ENGINE - General (72-00-00) - Fuel manifolds coupling nuts re-torque for containment action

Service bulletin

DMC: PASSPORT20-A-72-00-0142-00A-930A-D
Language: sx/US
Issue No: 001
Issue Date: 11 May 2022
Title: ENGINE - General (72-00-00) - Fuel manifolds coupling nuts re-torque for containment action - Service bulletin

Figure 1: Fuel nozzle area

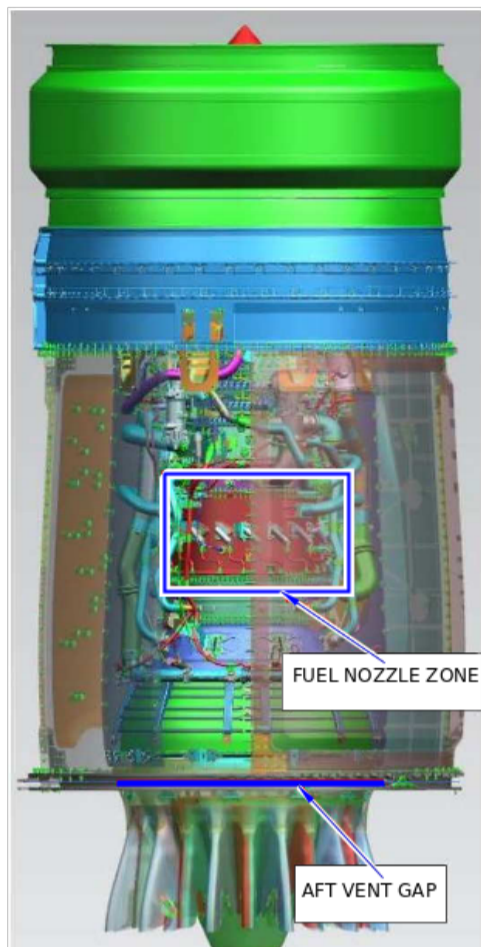
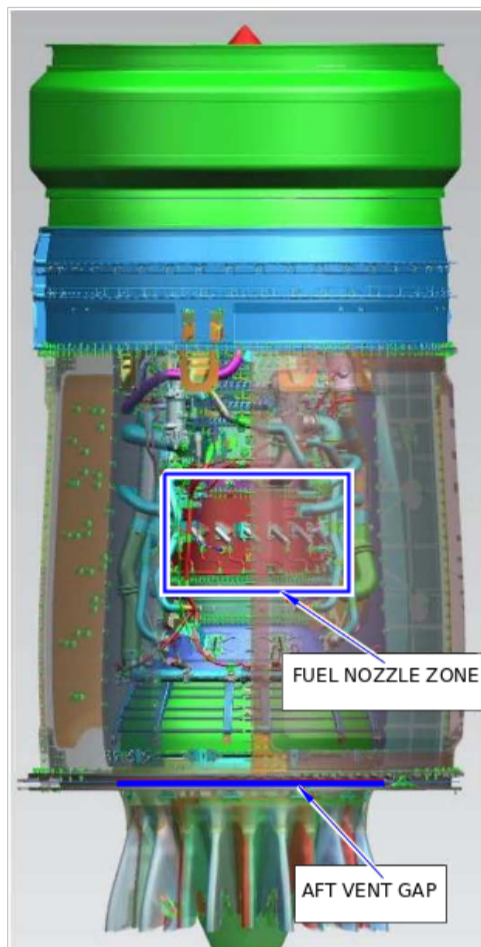
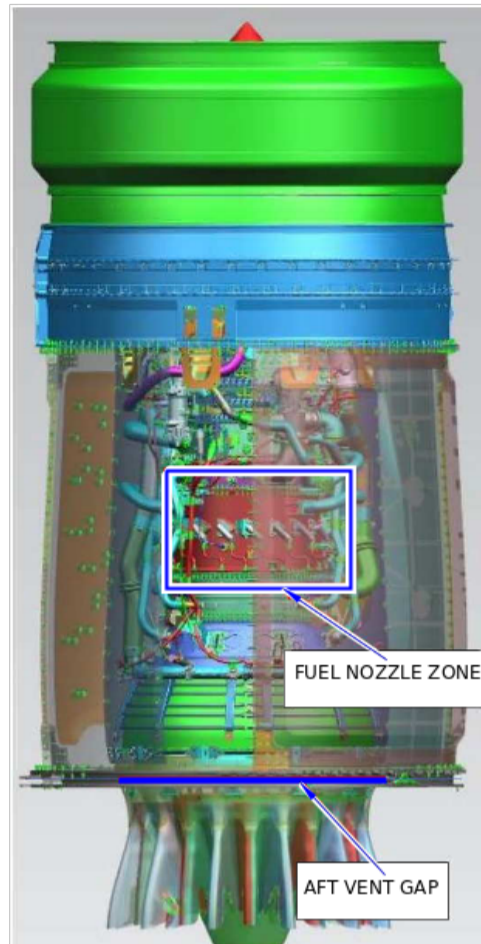
- (1) Deactivate the thrust reverser for maintenance. Refer to BD700-AJ78-30-00-00AAA-560A-A (Thrust Reverser (for Maintenance) - Deactivation procedure).
- (2) Open the upper fan cowl (432AT)/(442AT). Refer to BD700-AJ71-12-01-00AAA-540A-A (Upper fan cowls (432AT/442AT) - Open for Access Procedure).
- (3) Open the lower fan cowl (432AB)/(442AB). Refer to BD700-A-J71-13-01-00AAA-540A-A (Lower Fan Cowl (432AB/442AB) - Open for Access Procedure).
- (4) If necessary, remove the mixer assembly. Refer to [Mixer assembly - Remove procedure \(DMC-PASSPORT20-A-78-10-01-01A-520A-D\)](#)
- (5) For the right-hand engine, do as follows: Refer to [Figure 1](#)

(8) Access the fuel nozzle zone where the fuel manifolds (34400) and (34401) connect to the fuel nozzles (12500) and (12501). Refer to [Figure 1](#)

Figure 2: Fuel nozzle locations, ALF

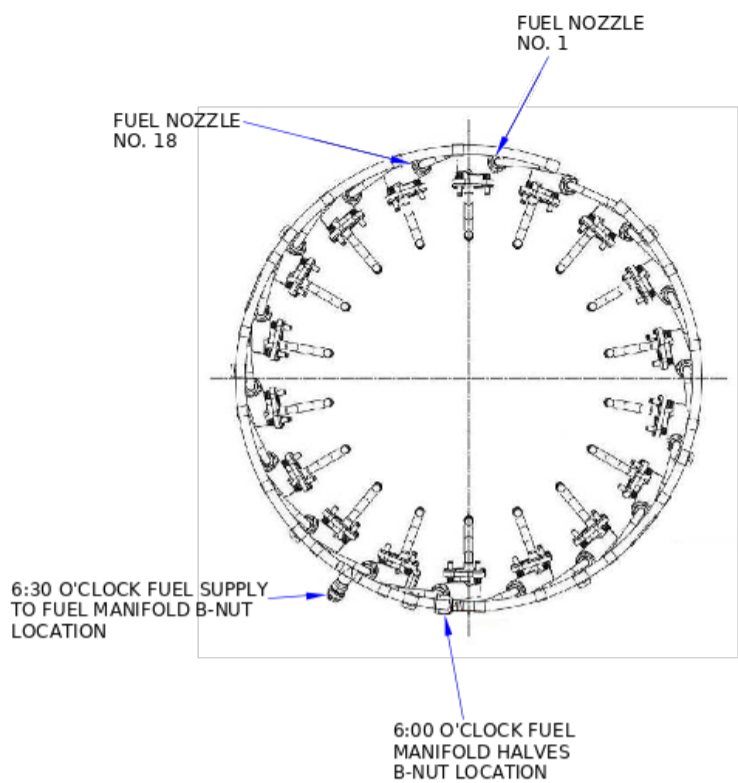
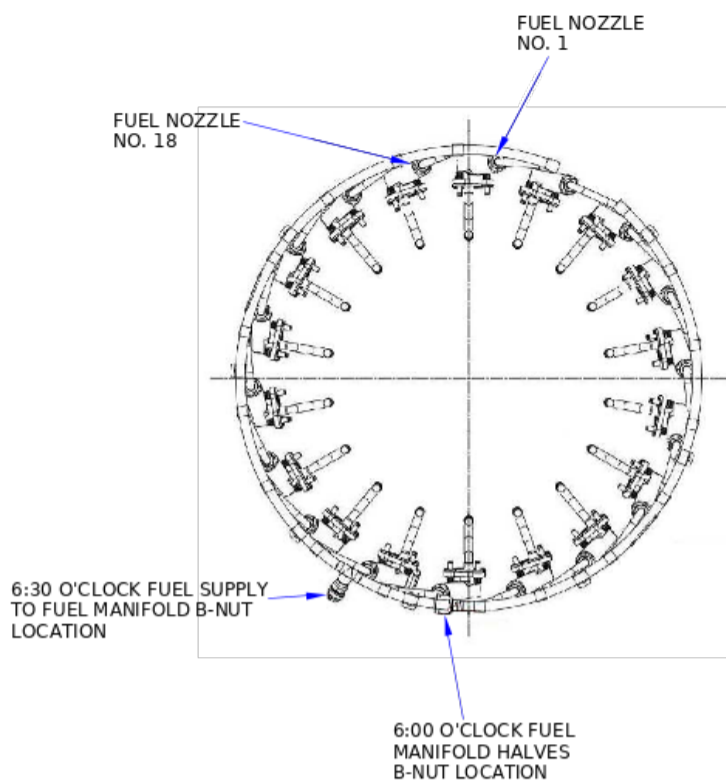
(9) Identify fuel nozzle No. 1 at 12 o'clock position aft looking forward (ALF) .

Note: Fuel nozzle No. 1 starts on fuel nozzle located at 12 o'clock and continues in a clockwise direction ALF. Refer to [Figure 2](#)

Note: Fuel manifold (34400) connects to fuel nozzles No. 2 through No. 9. Fuel manifold (34401) connects to fuel nozzles No. 1 and No. 10 through No. 18. The torque value is the same for all.

Note: On fuel nozzles No. 7 and No. 9, ALF, ([Figure 2](#)

- (e) Clean the coupling joints and surrounding areas with a lint-free cloth.
 - (f) If necessary, safety the coupling nut on the fuel manifold to the fuel nozzle with safety wire or safety cable. Refer to [SPM TASK 70-11-01-400-005 \(Safety wire procedure\)](#) or [SPM TASK 70-11-02-400-006 \(Safety cable procedure\)](#).
- (14) Report findings and photos of the coupling nut showing final position of the line marks back to GE via 24/7 Business Aviation Support. Refer to step (40) at the end of this document for details.
- (15) Visually make sure that all safety wire or safety cable is present on the coupling nuts before proceeding to the next step.
- (16) Identify the 6:30 o'clock fuel supply tube (34402) to fuel manifold (34401) B-nut location. Refer to [Figure 2](#)

(21) Identify the 6:00 o'clock fuel manifold halves (34400) and (34401) B-nut location. Refer to [Figure 2](#)

Figure 3: Initial coupling nut to nozzle position - line mark examples

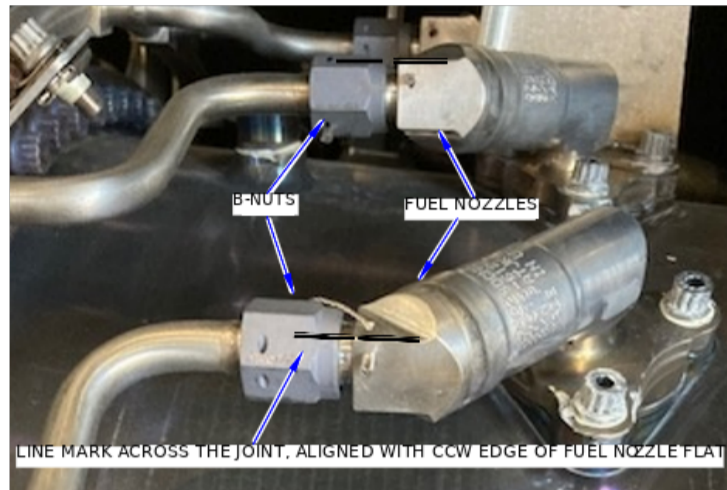
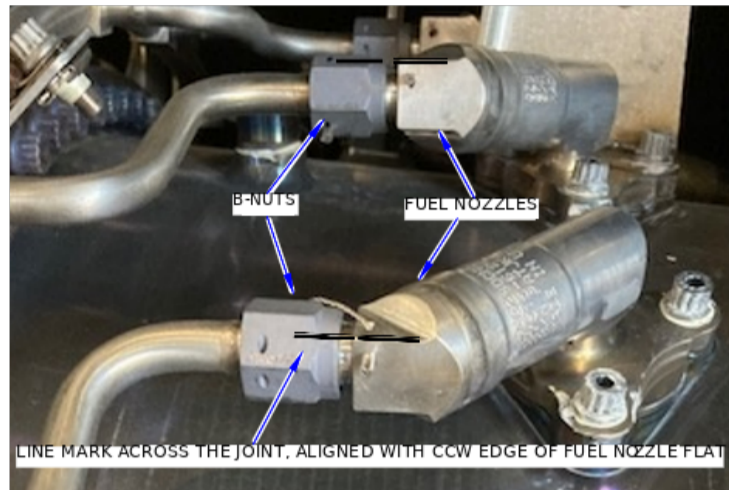
- (10) Visually examine the fuel nozzle to fuel manifold coupling nuts at all 18 locations for evidence of fuel wetting.
- (11) If fuel indications are observed, contact your GE field service engineer or 24/7 Business Aviation Support. Refer to step (40) at the end of this document for details.
- (12) With an approved marker, draw a line across the joint to mark the coupling nut to nozzle position at all 18 locations. Align mark with the ALF counter clockwise (CCW), edge of the fuel nozzle flat. Refer to [SPM TASK 70-16-02-350-017 \(Temporary Marking\)](#). Refer to [Figure 3](#)

Figure 4: Final coupling nut to nozzle position - line mark example

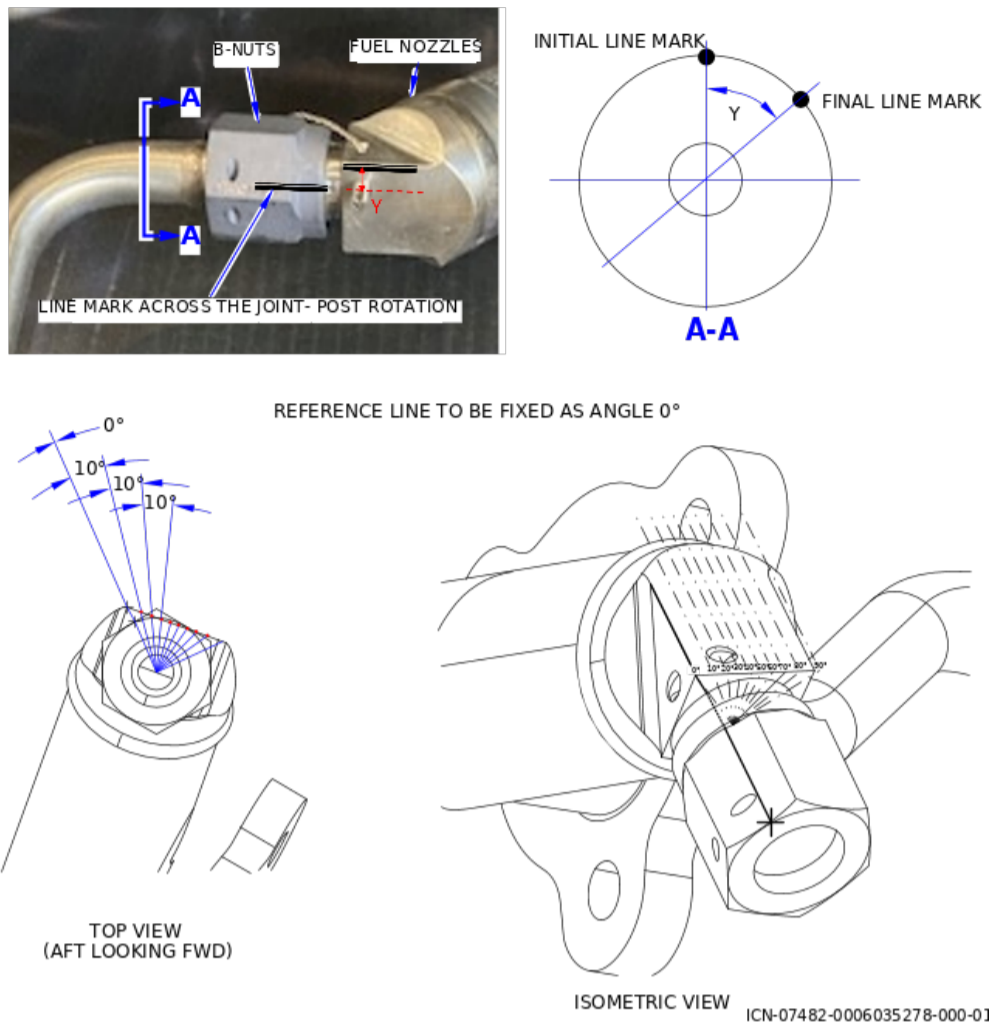
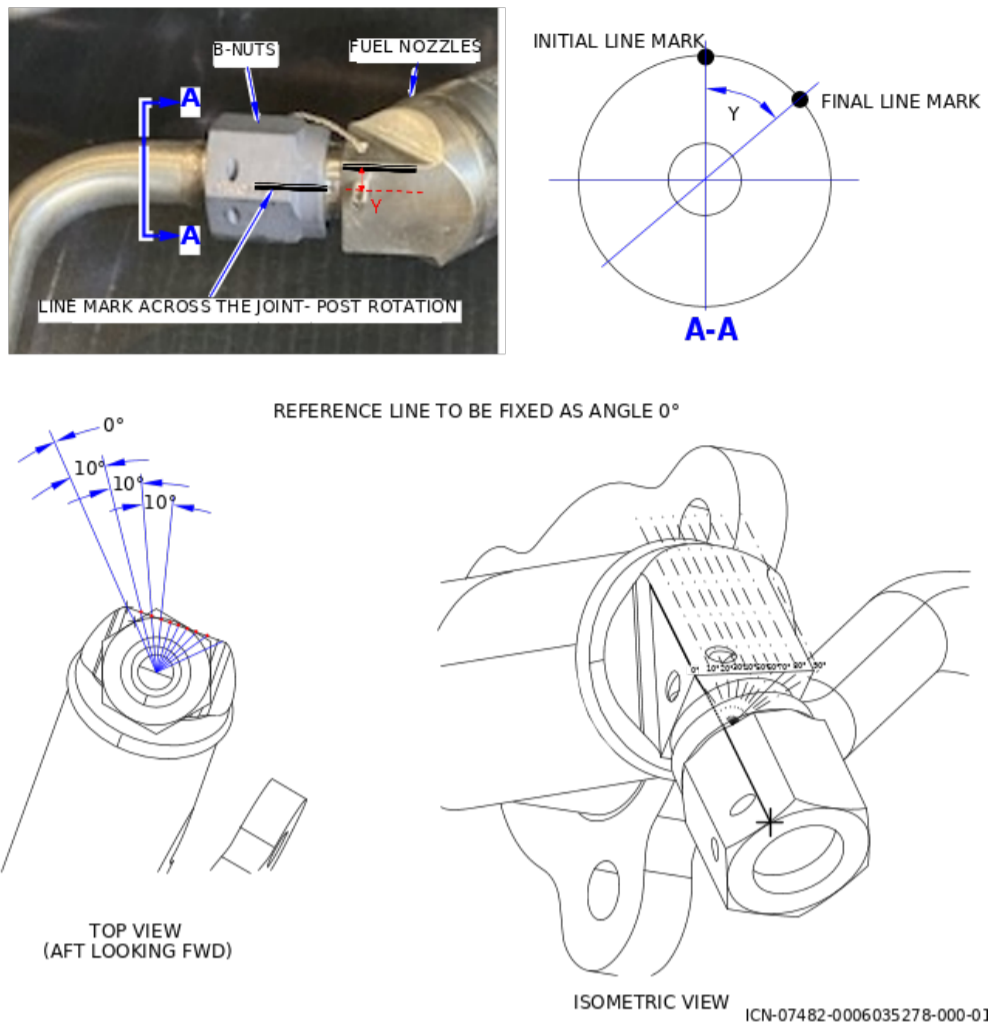
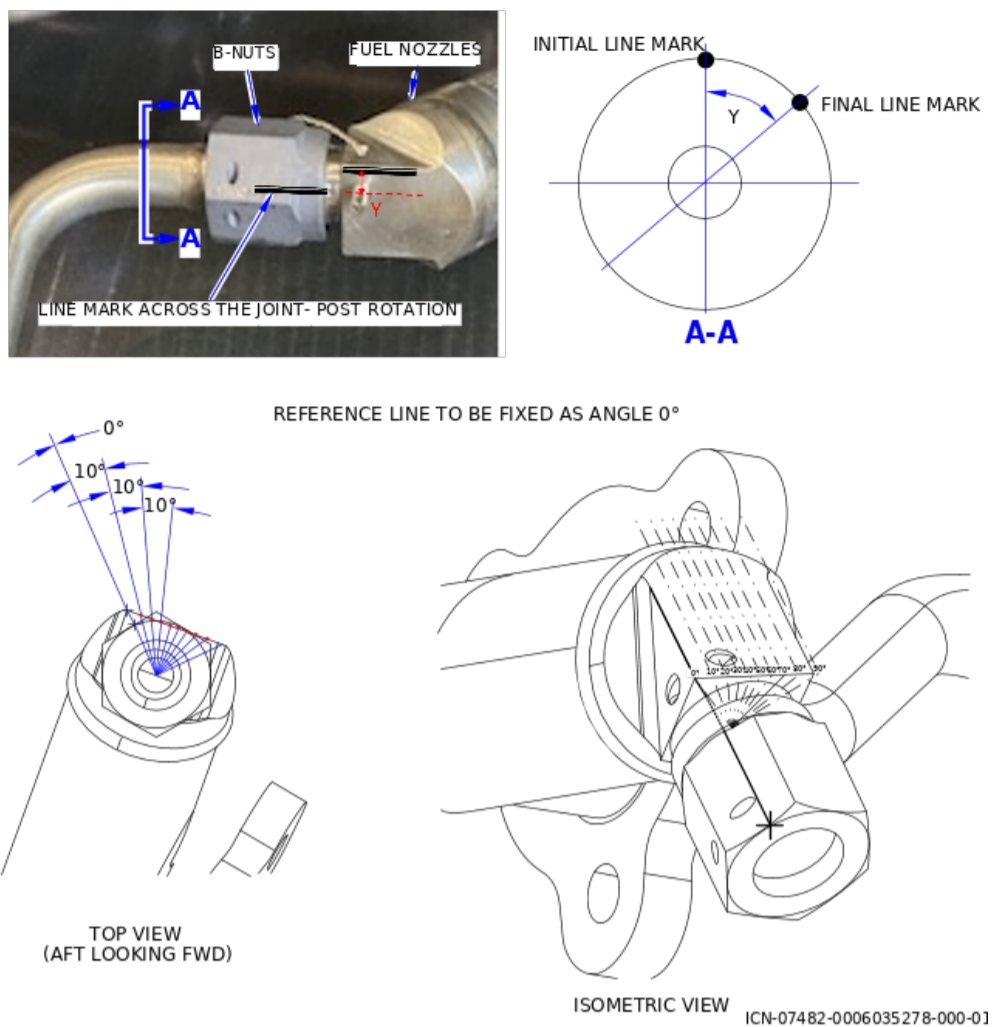
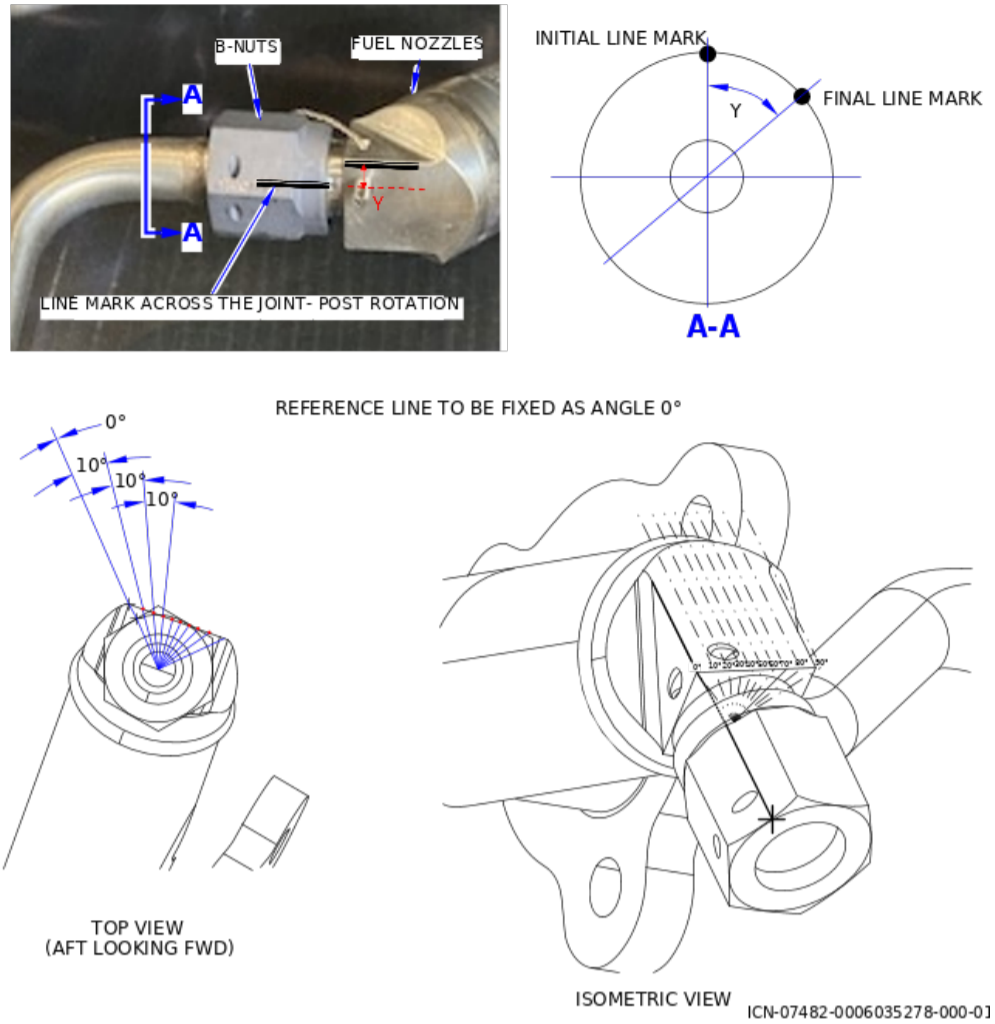
- (a) If necessary, remove the safety cable to access the coupling nut for tool clearance.
- (b) Set the torque wrench to get 285 lb in. (32.2 Nm).
- (c) Torque the coupling nut to get 285 lb in. (32.2 Nm) +/- 8 percent.
- (d) If the coupling nut turns before get the set torque, remove the safety cable and complete the torquing process. Use the line marks added in step (12) to measure the angular rotation of the coupling nut after you get the 285 lb in. torque. Refer to [Figure 4](#)

- (d) Torque the coupling nut to achieve 720 lb in. (81.4 Nm) +/- 8 percent.
 - (e) If the coupling nut turns before you get the set torque, remove the safety cable and complete the torquing process. Use the line marks added in step (a) to measure the angular rotation of the coupling nut after you get the 720 lb in. torque. Refer to [Figure 4](#)

- (e) If the coupling nut turns before you get the set torque, remove the safety cable and complete the torquing process. Use the line marks added in step (a) to measure the angular rotation of the coupling nut after you get the 500 lb in. torque. Refer to [Figure 4](#)
